AP1000 DOCUMENT NO. APP-GW-GLR-134	REVISION 4	PAGE 1 of 566	ASSIGNED TO W-Sisk	OPEN ITEMS (Y/N)
---------------------------------------	---------------	------------------	-----------------------	------------------

**TITLE: AP1000 DCD Impacts to Support COLA Standardization**

# **AP1000 Standard Combined License Technical Report**

## **AP1000 DCD Impacts to Support COLA Standardization**

Figure 3.8.2-4 (Sheet 5 of 6)

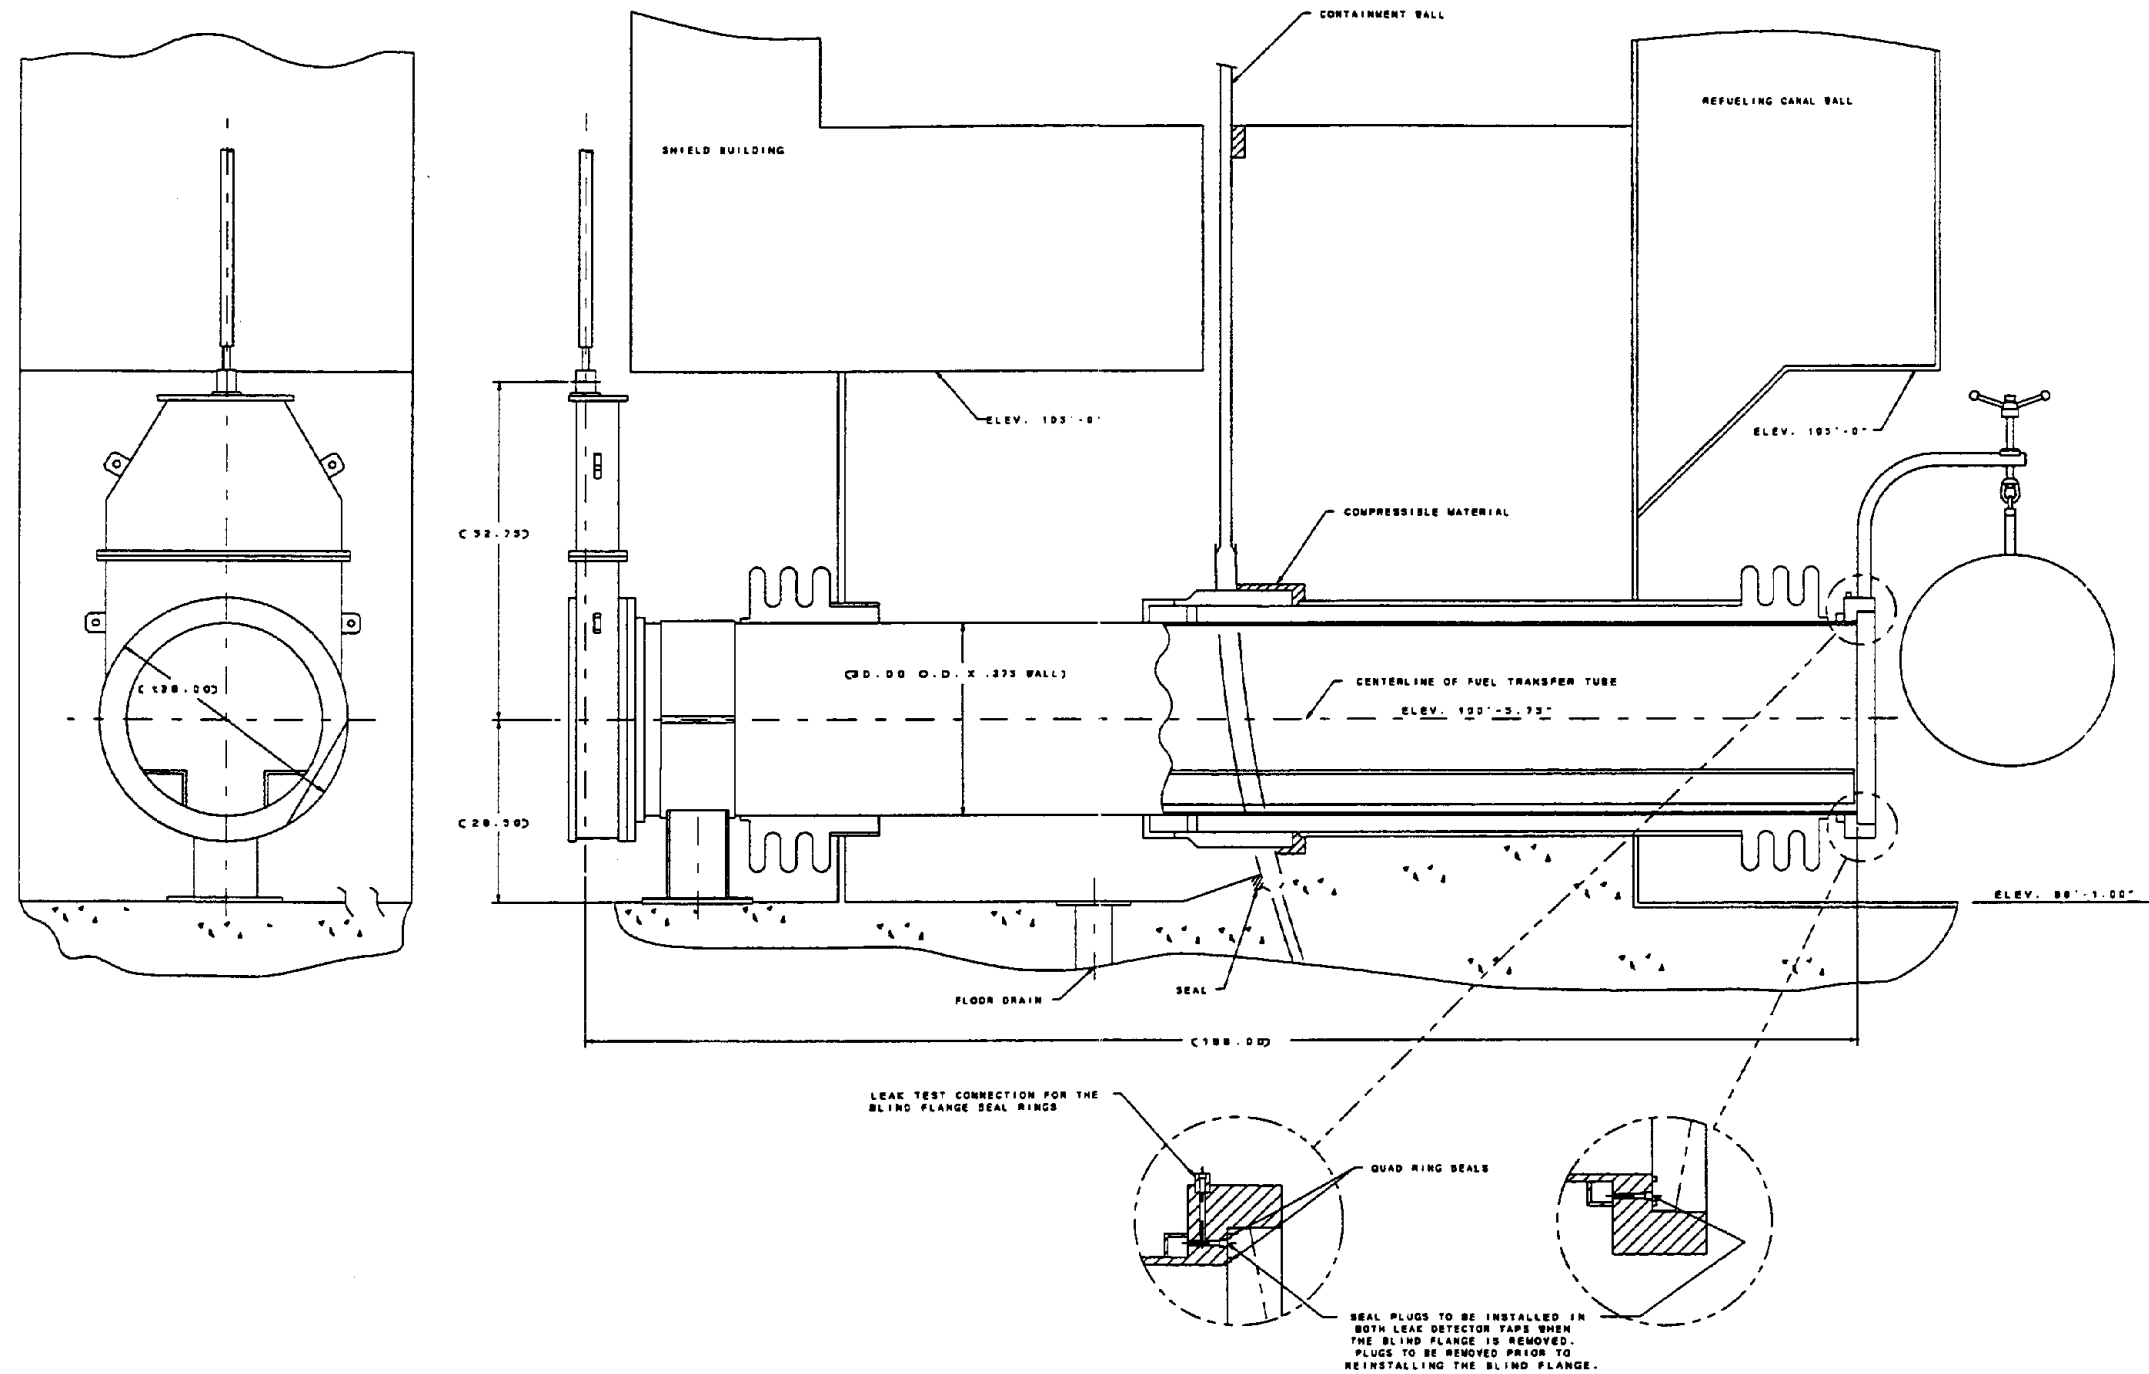
**NRC044 contains corrections to Table 3.2-3, Figure 3.8.2-4 of DCD Revision 16. The basis for the change is RAI-TR09-003.**

Figure 18.2-3

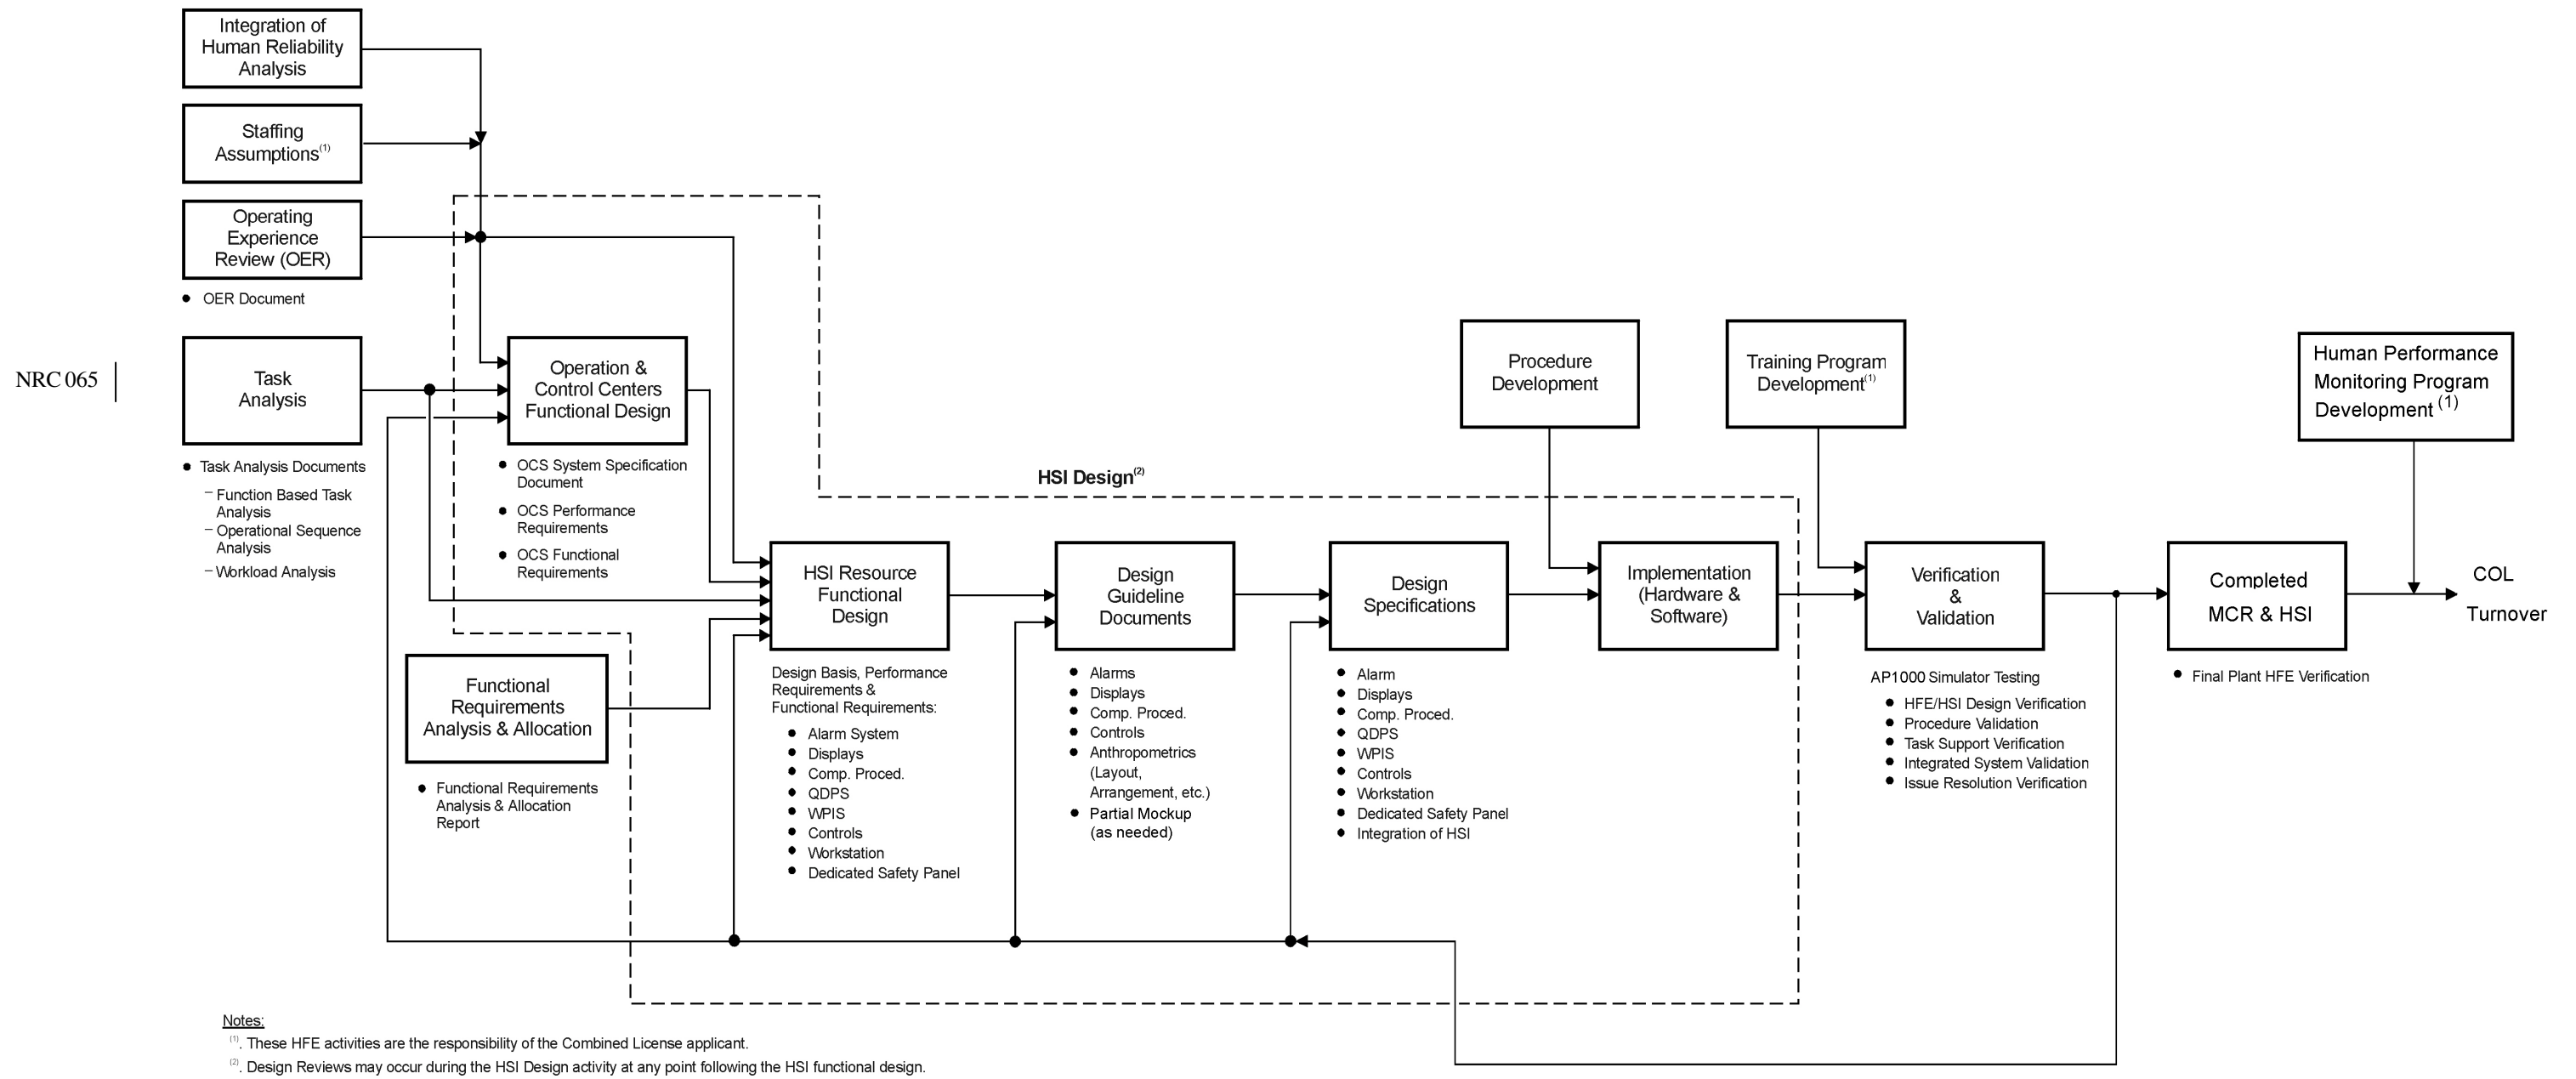
NRC065 contains an editorial correction to delete the parenthetical reference to Note 1, (1), in the box containing the words "Procedure Development" on DCD Figure 18.2-3

The basis for this deletion is Revision 1 of Technical Report 70, APP-GW-GLR-040, which closes COL Applicant actions with respect to Operating Procedure development. In addition, this deletion will ensure that Figure 18.2-3 of the DCD is consistent with Table 1.8-2 which clearly states that, with respect to COL Information Item 18.9-1, there are no COL Applicant or COL Holder actions required.
